## **ADDENDUM NO. 1**

**HALLSVILLE ISD BOBCAT STADIUM PARKING LOT EXPANSION**

**TUESDAY, SEPTEMBER 30, 2025.**

**Addendum No.1, Item 1: To the drawings, Sheet C6.2 has been added to the plan set.**

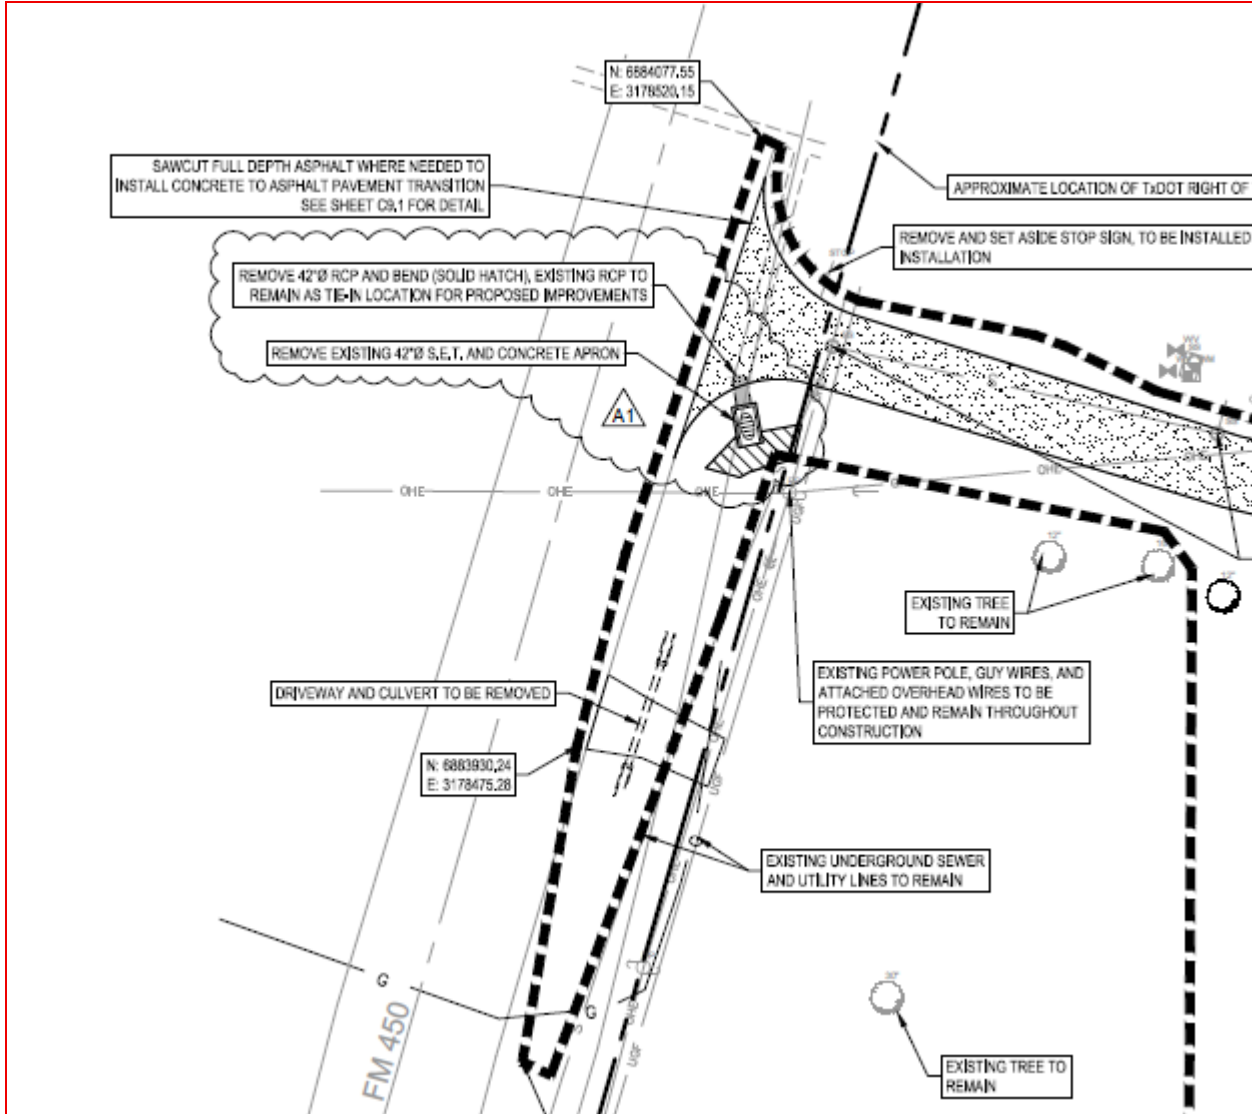
- 1. QUESTION:** Please clarify what Line Item #20 on the bid form is to include. Is this lime stabilization?  
**RESPONSE:** There is no lime stabilization on this project. Item 20 is the compaction and moisture conditioning of the 8" subgrade, in advance of forming and placing the concrete pavement.
- 2. QUESTION:** The demolition sheet only calls for the removal of RCP Pipe. The existing conditions appear to be a concrete end section and a concrete flume in this area. The new site plan calls for an area inlet to go back at this location. Standard practice would be to connect to the existing RCP with new RCP, extend the pipe run, and daylight to a new SET. C3.0 Demolition Plan - Existing Drive

Entrance C4.0 Site Plan - New Drive Entrance C4.0 - N Callout Please confirm the required scope of work to be priced at the new driveway crossing.

**RESPONSE:** Sheet C6.2 has been added to the plan set. We inadvertently left out the plan sheet in the original plan set. In summary, the scope of work includes removing the existing concrete S.E.T. and concrete rip rap, removing a portion of the 42" RCP and 45 deg bend, connecting to the end of the pipe with new 42" RCP, constructing a concrete collar and installing 45-ft of 42" RCP and a 5'x5' area inlet with one opening on the south side of the inlet.

**NOTE:** *The concrete collar connection for the 42" RCP is subsidiary to Pay Item 39.*

*Pay Item 51 has been added to the bid sheets to capture the cost of "Demolish & Remove 42" SET, 42" RCP, 45 Degree Bend, & Concrete Rip Rap per plans and specifications".*

## 6" PIPE BOLLARD DETAIL

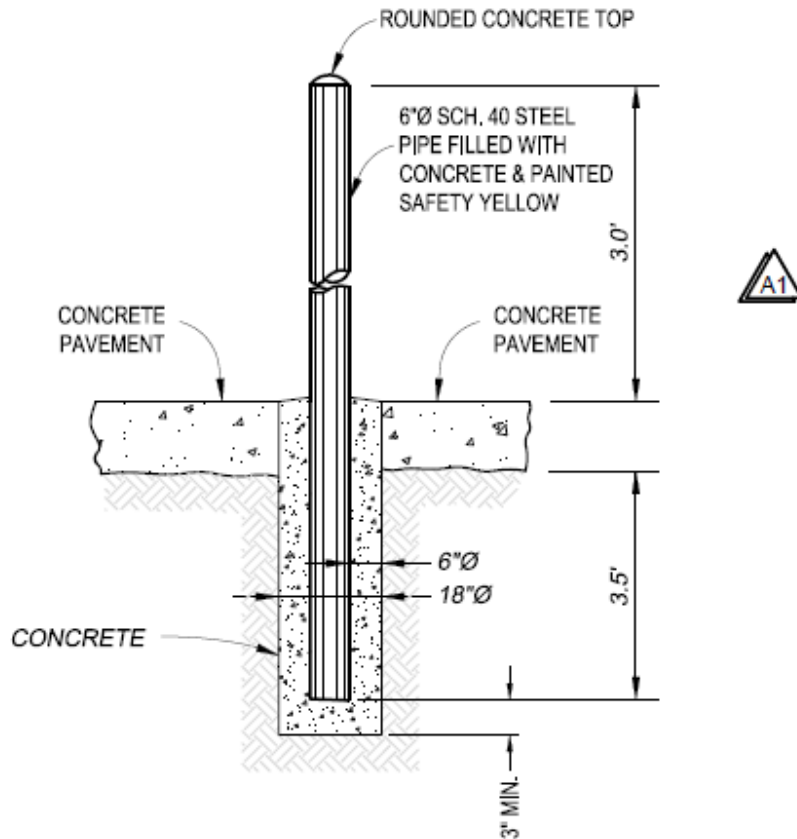
3. **QUESTION:** Please clarify if the steel bollards are galvanized or not.

5. **QUESTION:** 1. Just to confirm Bollards are to be galvanized and painted. A special primer will have to be used to paint the galvanized bollards. 2. Will we be required to cover concrete testing for the job? 3. Will we have to coordinate with AEP for the removal of the power poles and lines? If so, is there a cost? Will the new power be run prior to relocation? Is there any expected outages? If so, is there a certain timeframe it can be down?

**RESPONSE:** No, Galvanizing the steel pipes will not be required. See revised bollard detail at end.

- 1) Galvanization of the pipe bollards is not required. See revised detail.
- 2) Concrete Testing will be paid for by the owner.
- 3) A. Yes, contractor to coordinate and schedule the removal of the power poles and lines  
B. Any cost associated with the power line removal will be deducted from the miscellaneous construction allowance. We do not expect there to be any costs for this.  
C. Power will be from the existing pad mounted transformer to the new control panel.  
D. Power to the transformer will be temporarily shut off (by AEP) in order to make the connection inside the transformer. Coordination with the owner and AEP will be required for this connection.

**BOLLARD FINISH NOTES:**

1. PROVIDE 6 INCH DIAMETER SCHEDULE 40 BLACK STEEL PIPE, FILLED WITH CONCRETE AS SHOWN ON THE DRAWINGS.
2. PREPARE EXTERIOR STEEL SURFACES BY REMOVING ALL MILL SCALE, RUST, AND CONTAMINANTS IN ACCORDANCE WITH SSPC-SP6 (COMMERCIAL BLAST CLEANING) OR EQUIVALENT.
3. APPLY ONE COAT OF HIGH-BUILD EPOXY PRIMER WITH A MINIMUM DRY FILM THICKNESS (DFT) OF 4.0 MILS.
4. APPLY TWO COATS OF ALIPHATIC POLYURETHANE (SAFETY YELLOW) WITH A TOTAL DFT OF 6.0 MILS MINIMUM (3.0 MILS PER COAT).
5. PROVIDE A TOTAL PAINT SYSTEM DFT OF NOT LESS THAN 10.0 MILS.
6. FINAL COLOR SHALL BE SAFETY YELLOW, OSHA #13655 (OR EQUAL).
7. TOUCH UP ALL FIELD WELDS, ABRASIONS, OR DAMAGE TO COATINGS WITH EPOXY PRIMER AND POLYURETHANE TOPCOAT TO RESTORE FULL PROTECTION.
